**Airworthiness Directives; Eurocopter France Model AS-365N2, AS 365 N3, EC 155B, EC155B1, SA-365N, N1, and SA-366G1 Helicopters**

**ACTION:** Notice of proposed rulemaking (NPRM).

**SUMMARY:** This document proposes to revise an existing airworthiness directive (AD) for Eurocopter France (Eurocopter) Model AS-365N2, AS 365 N3, EC 155B, EC155B1, SA-365N, N1, and SA-366G1 helicopters. That AD currently requires inspecting the main gearbox (MGB) base plate for a crack and replacing the MGB if a crack is found. This action would increase the

Figure 1

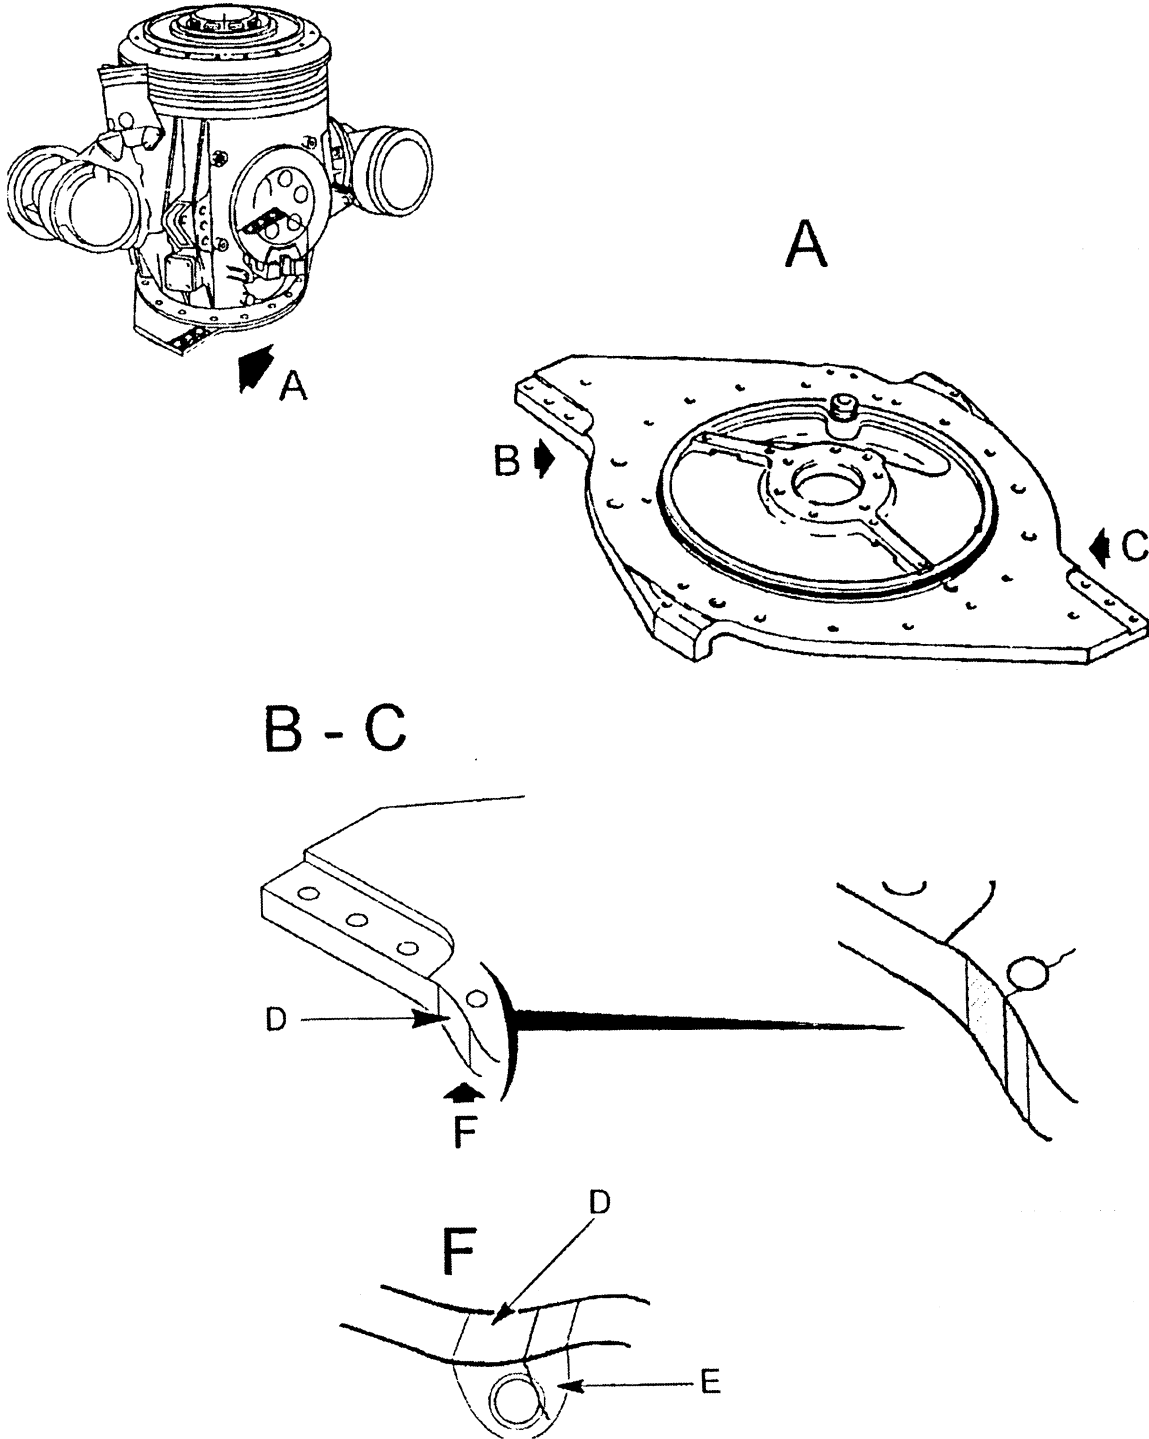
strip the paint from area "D" on both sides ("B" and "C") of the MGB base plate as depicted in Figure 1 of this AD.

(b) At the times indicated in the compliance table, inspect area "D" of the MGB base plate for a crack using a 10x or higher magnifying glass. Area "D" to be inspected is depicted in Figure 1 of this AD.

(c) If a crack is found in a MGB base plate, remove and replace the MGB with an airworthy MGB before further flight.
